# UNITED STATES PATENT AND TRADEMARK OFFICE

APPLICATION NO.	FILING DATE	FIRST NAMED INVENTOR	ATTORNEY DOCKET NO.	CONFIRMATION NO.
10/698,269	10/31/2003	William Gerald Wyatt	004578.1384	1666
45507	7590	06/06/2006	EXAMINER	
BAKER BOTTS LLP 2001 ROSS AVENUE 6TH FLOOR DALLAS, TX 75201			FORD, JOHN K	
			ART UNIT	PAPER NUMBER
			3753

**Office Action Summary**

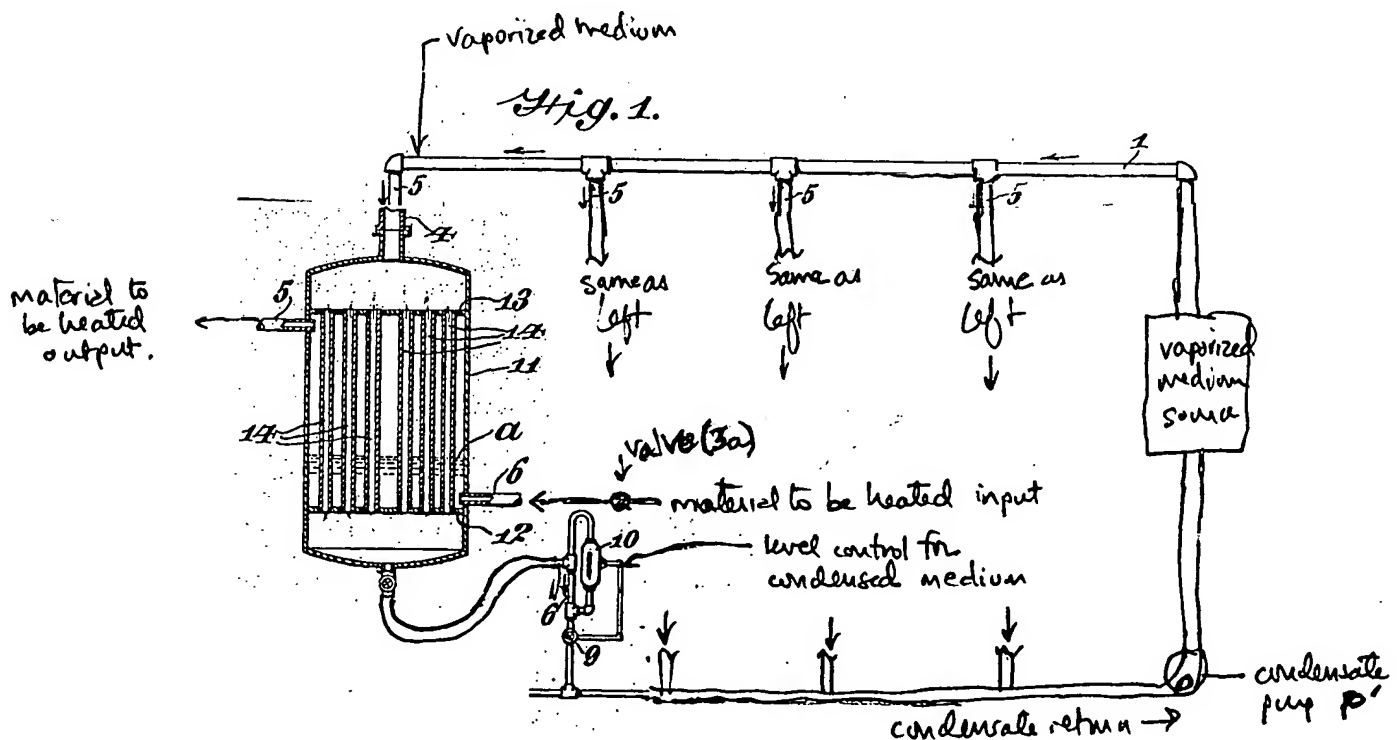
It is not understood, particularly in regards to claims 2 and 3, which disclosed "further conduit" is being claimed in claims 2 and 3. Are these conduits 93 and 94 or are they a claim to a further module as shown in Figure 2 at 21 and 22? The nature of the "predetermined direction" (claim 1) and the "approximately perpendicular to said predetermined direction" (claim 2) and "further direction" (claim 4) is particular unclear because no particular "direction" relative to some identifiable heat exchange structure is specified. Without some reference direction these directions could be in any arbitrary direction. Please specify these directions relative to the rest of the claimed structure.
